RECEIPT DATE: 8.1.22 **ONSITE SEWAGE DISPOSAL SYSTEM** P 572115  
 APPROVAL DATE: 1/11/23 **PERMIT: CONSTRUCTION** A \_\_\_\_\_  
 PROPERTY ADDRESS: 12451 Kondrup Dr.  
 SUBDIVISION: Beaufort Estates LOT: 20 TAX ID: \_\_\_\_\_  
 CONTRACTOR: Freedom Septic EMAIL: \_\_\_\_\_  
 CONTRACTOR ADDRESS: \_\_\_\_\_ PHONE: \_\_\_\_\_  
 PROPERTY OWNER: C2M LLC EMAIL: \_\_\_\_\_  
 OWNER ADDRESS: 12466 Kondrup Dr PHONE: \_\_\_\_\_  
 SEPTIC TANK SIZE (GALLONS): 2,000 TANK MANUFACTURER: Babylon Vault  
 PUMP MODEL: WE03L PUMP SIZE: 1/3 PUMP TANK CAPACITY: 2,000

The OSDS Plan for 12451 Kondrup Drive Lot 20 has been reviewed with the following comments:

**ONSITE SEWAGE DISPOSAL PLAN  
 BEAUFORT ESTATES, LOT 20**

12451 KONDURUP DRIVE

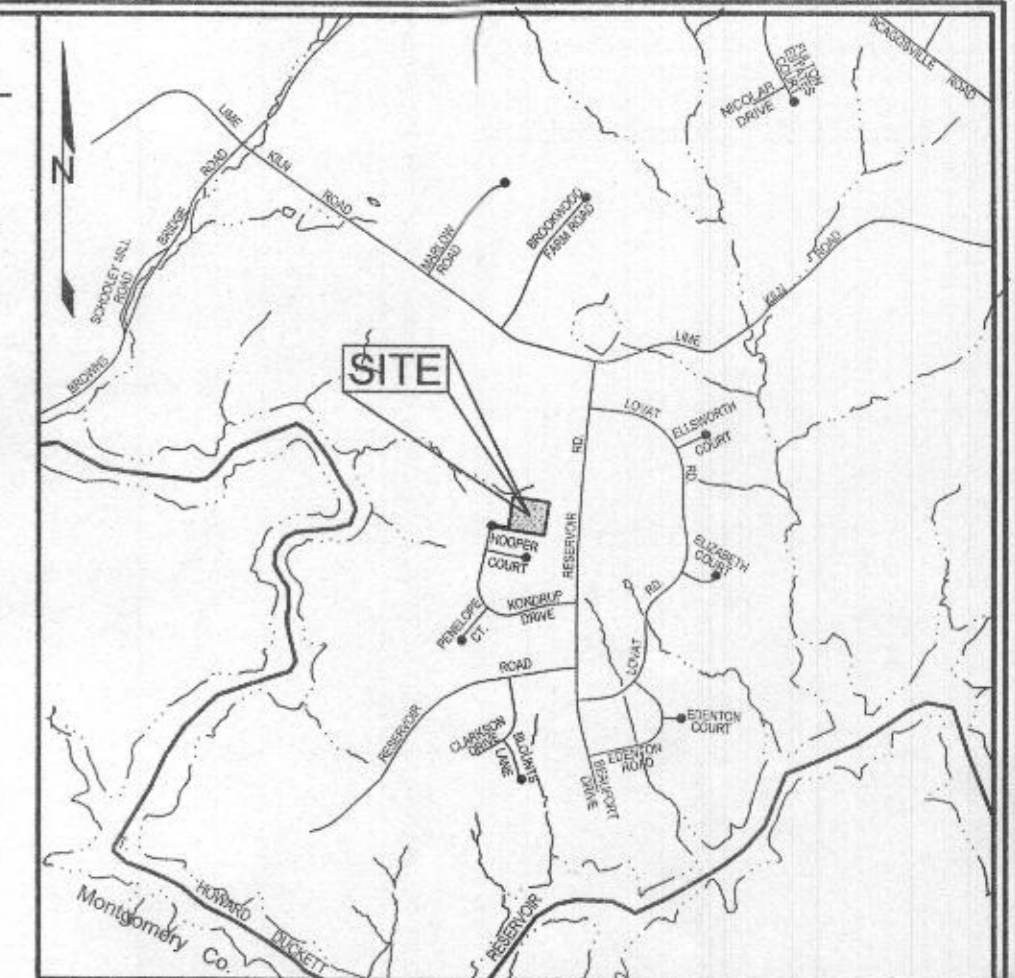
1. The SHC from the house to the first cleanout is less than 1%.  $435.07$  (Inv. Elev @ 5 ft from house) –  $434.58$  (1<sup>st</sup> cleanout) =  $0.49 / 49 \text{ ft} + 5 \text{ ft} = 0.91\%$
2.  $436.19$  (FF elevation) –  $435.07$  (Inv. Elev @ 5 ft from house) =  $1.12$  How will this work when the floor is 1 foot?
3. The plan doesn't show the SHC sleeved underneath the driveway on the first page and on the profile.
4. The existing well should be labeled with the tag # next to it.

I'm concerned if the house elevation drops, we won't make appropriate fall. Also, the SHC must be sleeved underneath the driveway. Is there room to show one or two replacement well sites? I overlooked these items on my review.

- 1.) Trench spacing = 2 (d) + w = 2 (3.5) + 3 = 10 feet (spacing is measured edge to edge) Will correct.
- 2.) Label perc test holes and provide elevations for each. Will add.

- 3.) SHC fall to tank may not be less than 1 % (ideally 2 – 5 %). We had a tough time with the cover and fall; we'll get it to 1%, but I don't think I can get to 2%.
- 4.) Static Head = highest point in system - pump off elevation =  $437.07 - 431.18 = 5.89$  I've always used the tank bottom plus 6". That is the lowest point of the pump suction (actually a couple inches higher because of the pump legs, but we ignore that). I think this should stay as we've shown.
- 5.) The GPM will likely reach 65 on the curve at 11 TDH. On the pump curve we've always shown the intersection of the design GPM and TDH, not the maximum GPM at the TDH. Should we change that? If so, do we need to recalc for 65gpm?

Yep, 1% minimum and all three trench systems have been reworked to hold a 10' separation.

Well, they did pretty darn good: 2 hundredths high. GP FF = 437.50 Top of Wall = 436.19 Joist system = 1.33' New FF = 437.52

the rear of the house, and we've already sank the tanks as much as possible. The connection is coming out of the house at that corner, which is the first floor of the house, not under the garage slab. We had discussions with the builder how best to make this work at that was the result. See the first floor plan attached. Could you move the invert to the back side of the house and place the tanks at the bottom of the SDA (away from the swale and steep slopes) and run the FM around and back up to the top of the SDA? That seems like a lot of extra run (~200' versus ~400') and maintenance complications to run it that way. The septic tank is currently ~100 feet from the driveway across flat ground, putting it at the bottom of the SDA would put it ~150 away and down steeper slopes.

Comment # 4 – We like to stick to the static head calculation that comes from the Sand Mound Manual. Ok, I see that. I hate to say it, but I've always done it this way. Lol We'll start using the pump off elevation.
